Track and Hut Engagement Session 2 March 2023

Milford Opportunities Hub – Te Anau

Figure 18: Node 2 - Eglinton reveal conceptual diagram (not to scale)

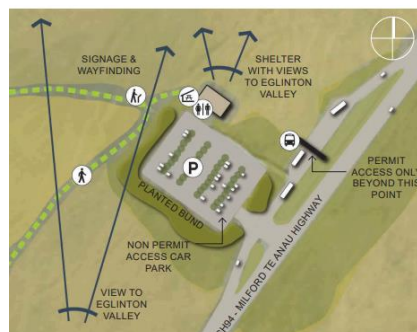
Feedback
Objective is to link to FTT.
There are over 40,000 passes per year on Lake2Lake already, track not finished. No question that there is demand for bike track.
What is planned service level for FTT section? Wilderness Trail, Grade 2 appears to be the sweet spot - very popular for older riders, locals, kids.
Accessibility, explicit about full access, wheelchairs etc. for bike track. Consideration for disability access within Master Plan? Needs to include access for younger age group, families with prams, trikes etc.
Grade 2 cycle trail would be used more (even with a few tricky bits), long sections 60 grade or less. Would be good for foot and bike traffic. Lots of people travelling around. Agree that Grade 2 with a few challenges would be the sweet spot. Would get used the most as a multiuse track. Great area to explore. Tracks like Wilderness Trail and Lake2Lake are good examples of tracks that cater for most.

Consideration on the impact track would have on camping.
Is there further capacity at Cascade Creek.
General support for track going through the valley, road is already there.
Provided an external reference about the benefits of a multiuse trail (MBIE report): https://www.mbie.govt.nz/dmsdocument/19854-2021-evaluation-of-nga-haerenga-great-rides-of-new-zealand-pdf
According to the 2013/14 Active NZ survey "Almost all participants took part in sport and recreation at one or more man-made facilities. The most popular being a path, cycleway or walkway in a town or city (53.1%)." Active NZ surveys: https://sportnz.org.nz/research-and-insights/surveys-and-data/active-nz/

The plan / notes could be explicit about the Reveal trail linking to the planned FTT trail at Te Anau Downs (jetty: some maps show 'Te Anau downs' as north of Retford hill). Initial plans only showed reveal to park boundary.

Short Walks at Te Huakaue Knobs Flat/ Kiosk Creek

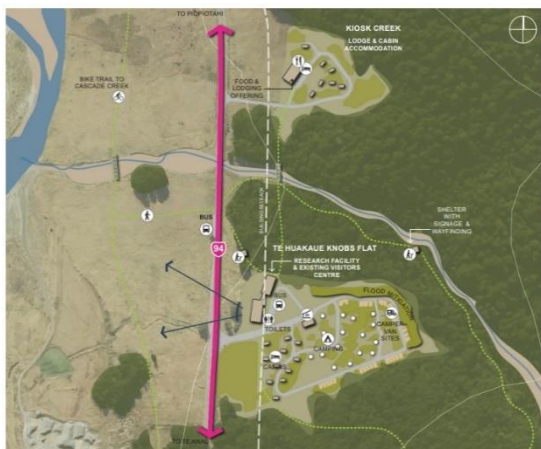
There are existing similar options e.g., Lake Gunn.

Enjoyed by people who require wheelchair and pushchair access.

Need to consider corridor / FNP, is that experience available elsewhere, and is it what people are wanting to do there?

Holistically, how much value would it add?

Cascade Creek is often full as accommodation is good.

Kiosk Creek's west-facing grassy terrace keeps the sun & are well suited to camping. Cascade has more developed flat pads suitable for vehicles.

Not that appealing to specifically go there for a day walk, but if you were staying there, the availability of a short walk(s) would be of value.

Short waterfall track already there - 25min return.

General support for short works. Potential for multiple short walks and potential to add some value for overnight option at Knobs Flat.

Hinepiwai Lk Marian Loop Walk

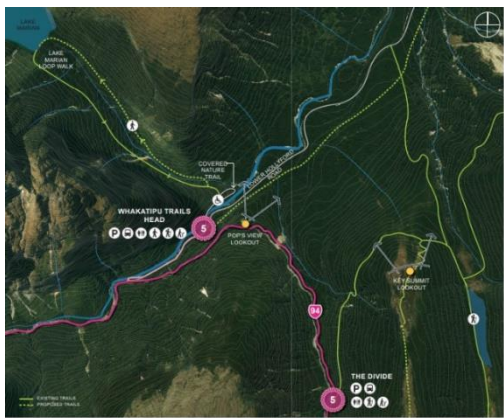
Feedback
<p>Why would you do a loop on what is a 'there and back' track - different if return loop track goes through something new."</p> <p>Loop track doubles the capital and maintenance costs.</p> <p>Strongly disagrees with the covered trail, diminish experience, increase cost and maintenance. Also, Visual impact (for users of trail and from afar). Won't be covered from car to track anyway so already need a coat or umbrella (which do the job of keeping rain off just fine).</p>
<p>Lake Marian track has confined space at the very beginning. Loop track could potentially take the pressure off, in the early stages off the track.</p>
<p>Divide key location, access to tracks.</p> <p>Lake Marian - Geotech issue, avalanche considerations on true left for loop.</p>
<p>Bottom section very high use, short stop travellers, guided. Combined space, congestion. Any loop track would be most helpful on bottom of track - up to the cascades. Otherwise control visitor numbers.</p>

<p>Strongly advocate for a loop track to Key Summit - improved visitor experience. Track promoted internationally. Lots of cross over on way up and down. Key Summit available year-round. Advocates for resilient / sustainable tracks - sustained through storm impacts. And improved experience. 400m ascent - 4hr round trip. On Great Walks, heavily advertised/demand. Lake Marian people have not heard of. Loop back to Divide (note Geotech relevant). Recommends this as the best half day experience. Loop provide 2 access points. Resilience of tracks would be improved.</p>
<p>Pass Creek to Lake Marian option? Too long for the half day loop.</p>
<p>Pass Creek - nominated when Divide access was questionable.</p>

Did not understand what the Marian Loop would be like. Interested in the proposals discussed though. Marin loop track looks like it might cover some rough and steep terrain – it will be interesting seeing where the final placement is. Interesting other proposals.

Generally, a loop supported in principle for visitor experience and track.

Figure 36: Node 6 - Gertrude Valley conceptual context diagram showing walking route to Gertrude Saddle (not to scale).

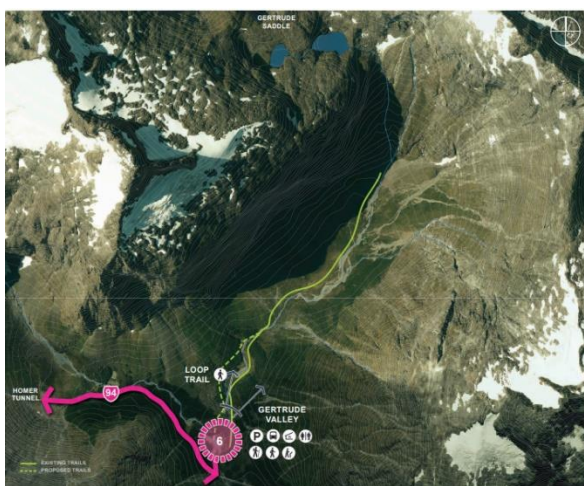
Feedback
Gertrude Valley walk - great scope for short walk loop. Track about the valley not the saddle.
Gertrude Saddle is already known, not creating a new hazard.
Great short stop, alpine flowers. Do not need to go up the saddle to get the experience. What is missing is the ability to stop in the alpine area and space and experience the Alpine flowers in the vista. It is a quintessential Fiordland experience.
Great majestic sense of place walking up the valley. Hazard mitigation, bunds etc - does not support - going into hazard then engineering out of it. The structures conflict with the objective of "Piopiotahi as it was forever". Hazard mitigation and infrastructure. Needs engineering and as soon as you build a structure then you are adding to some sort of environmental impact, and it is not part of the MOP vision.
Day visitors putting pressure on Alpine Club toilet and drinking water. New facilities would need to resolve this conflict and / or physical separation. Access for members to drive in but not for general use. The gravel in the creek keeps aggrading, needs maintenance to avoid flooding. Gertrude Saddle - lots of people come to strife irrespective of the signs. Is there potential to move the carpark to get people away from Gertrude Saddle?

General support for Gertrude but would require separation and engineering to avoid the conflicts.
Quiet enjoyment of the facility and risk to inexperienced visitors.

Nature Walk Loop:

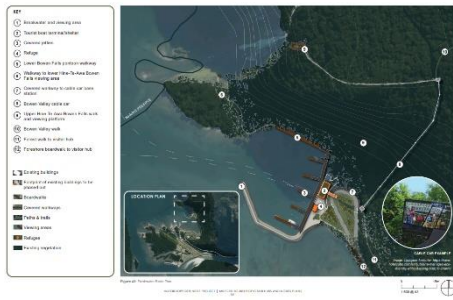
Already have the foreshore walk, available to everyone, free.

How long do you expect people to stay at Milford - how many options do they need? Unless you are staying overnight, unlikely to stay longer than 3hrs.

Hine-Te-Awa Bowen Falls Experiences:

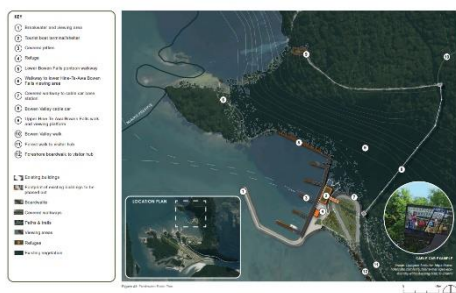
Feedback
Some method of getting up the Bowen for a walkway and look out over Bowen Falls.
Filled with dread the thought of a cable car, the visual impact of something moving. Less valley up Bowen Valley than Gertrude. These new structures can adversely impact other people's views.
Hydro pipeline needs replacing at some time, potential for a walkway up it. Existing infrastructure up to the penstock. The masterplan proposes some travelator walkway to Bowen falls.
Need to consider why people visiting the area, what is their expectation? Thinks it is about natural beauty not necessarily a structure etc. Is this about a colonised landscape, again inconsistent with the vision. Foreshore walk - gives vistas already. Put people at the top of views, they have an impact on other's observation. Cruise boats are a visual impact but a temporal one. If you can see the fiord from the structure, then you can see the structure / people from the fiord.

The longer people stay the more impact they have on power, water, waste, and hazard exposure. Instead of adding to Milford, you could subtract - move some things out of Milford?
Does not fit with the vision of the plan, 'NZ as it was forever'
Duplication with Barren Peak.
Any commercial feasibility in this?
Concerned about the visual impact

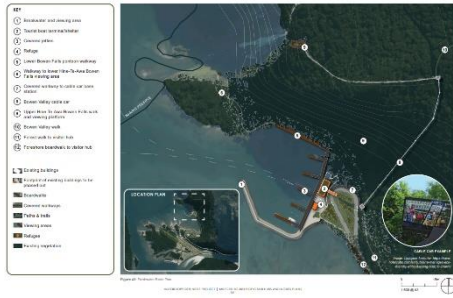
Impacts on visual amenity natural beauty could be diminished the natural features of the landscape and visitor experience the stated purpose the landscaping visit experience in the stated purpose on the MOP plan talks about *New Zealand as it was for the future*. This infrastructure did not seem to fit the plan.

If there was infrastructure, would need to be concealed.

Questions as to who would use it.

Every time you add something it creates pressure - creates an impact. What does it look like to the wider network not just a point-to-point issue but look at the whole scope in totality.

Lower Pontoon Walkway:

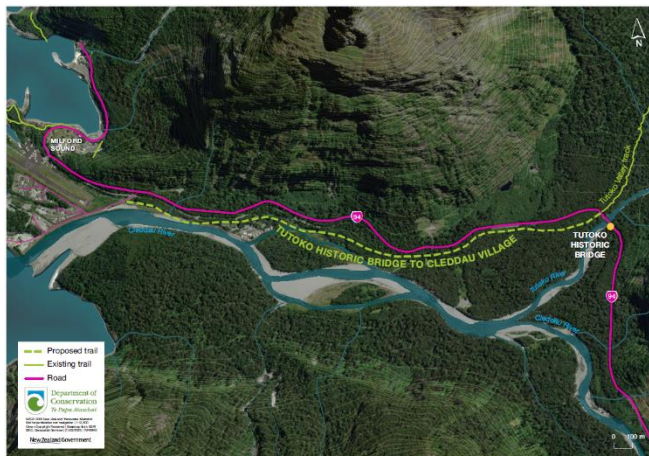
Bowen lower pontoon - hazard assessment? Known rockfall, tree slide hazard. Sceptical re the hazards.

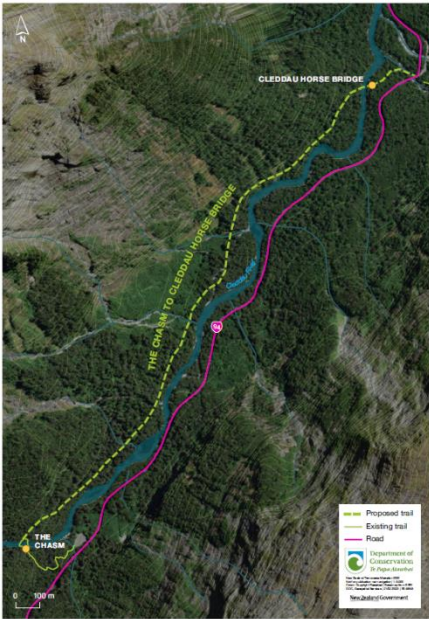
Have been canvassing DOC & NZTA for walking track to get people off the road.

Safety, speed. Helpful but still an issue. Have an informal track to a reasonable standard but needs a foot access culvert. Strong advocate for free options for people who go to. Declares a conflict of interest as any track would benefit Milford Lodge guests.

Currently guests walk down the road. There is already a formed track, but not good enough for some guests. Missing a culvert pipe

Milford Sound residents do not have access to exercise tracks to recreate in. Residents exercise on the road, they wait for the traffic to die away.
